**HISTORIC PRESERVATION BOARD**  
**City Hall – First Floor Board Room**  
**510 N. Baker Street, Mount Dora, Florida**  
**July 30, 2025 at 3:00 PM**

**RE:** **Tab 1 - Certificate of Appropriateness; 1029 E 5<sup>th</sup> Avenue (Location); Reroof (Metal Shingles to Asphalt Shingles (Proposed Work); Thomas Investment Properties, LLC (Owner); Steven F. Harris, Jenney Roofing, LLC. (Applicant).**

**DATE:** July 30, 2025  
**TO:** Historic Preservation Board  
**FROM:** Michele Janiszewski, AICP, Senior Planner  
**RE:** **Tab 2 - Certificate of Appropriateness; 625 N Tremain Street (Location); Porch and Foundation Modifications (Proposed Work); Leah C Germain (Owner); Vedder Construction (Applicant).**

**RE:** **Tab 3 - Certificate of Appropriateness; 102 N Clayton Street (Location); Remove Two Windows and Replace with Doors (Proposed Work); Paige Hargrave (Owner and Applicant).**

**NOT TOUCHING THESE FLAT ROOF FACETS  
(RF-11, RF-15, RF-19, RF-20)**

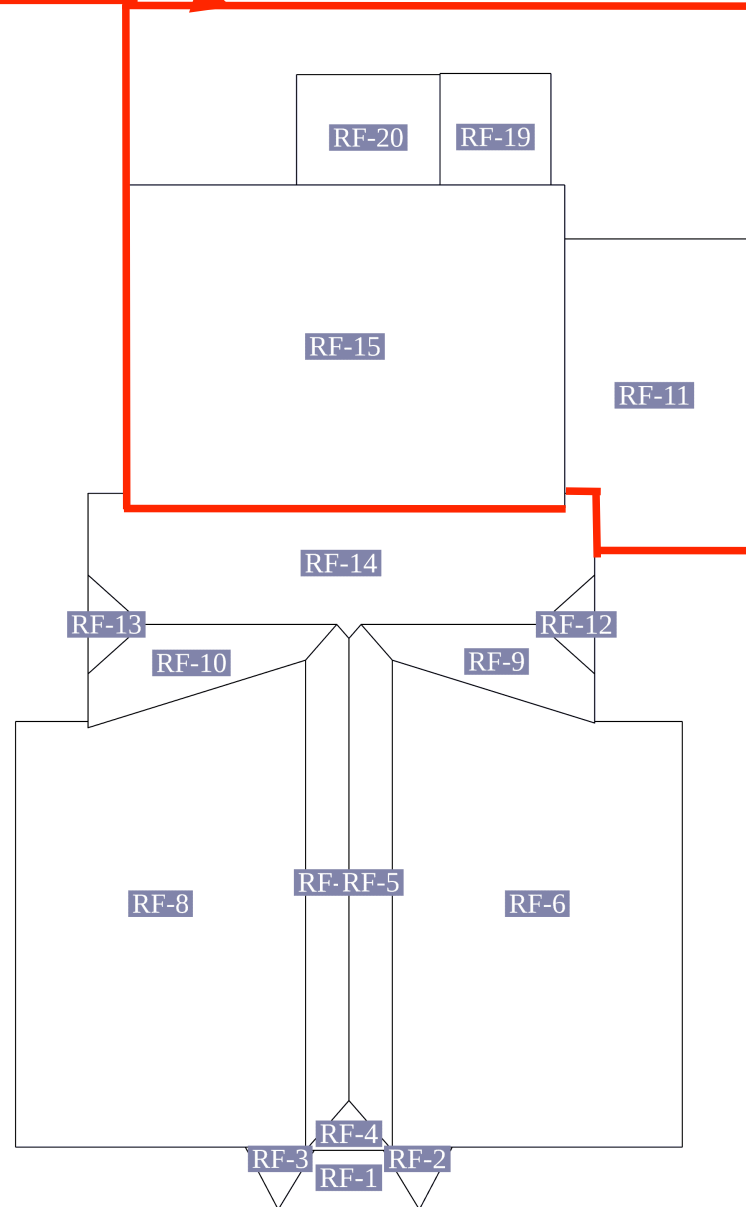
Full Description of Proposed Alteration(s) or Construction including materials; please attach additional documentation if needed: Re-roof main structure (Remove Metal/Install Shingles) not touching flat roof facets reflected on drawing. Reference P25-06-0164

CLAYTON VIEW

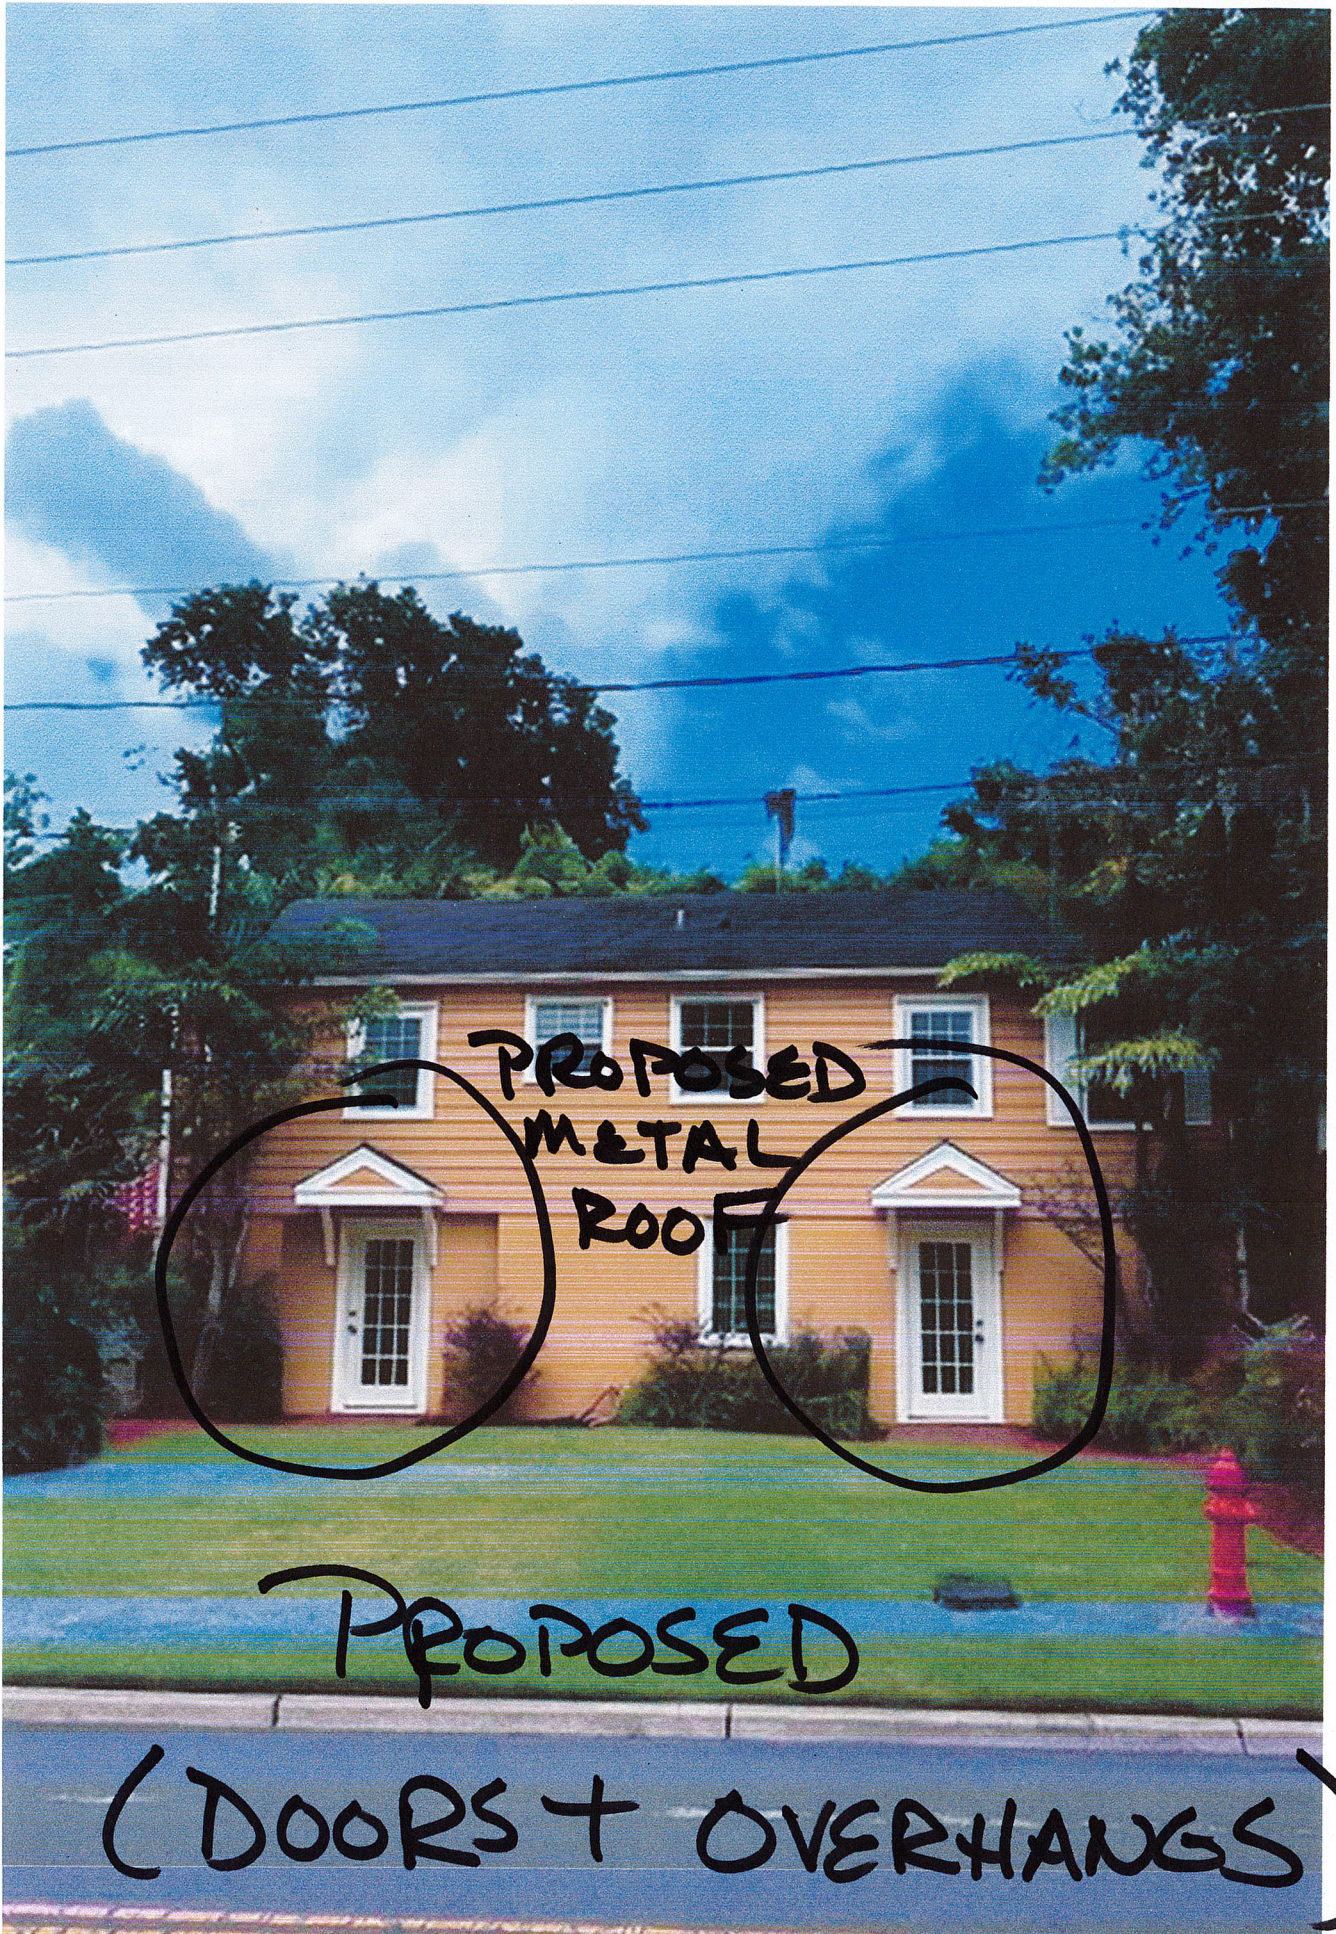
The Applicant is seeking to remove two, vinyl windows from the western elevation (along Clayton) and replace with two doors with metal awnings.

The following images provide "before" and "after" views. Please note that the "after" image is AI generated, and shows one door in a different position than the current window. This proposal includes two doors in the **same location as the existing windows**.
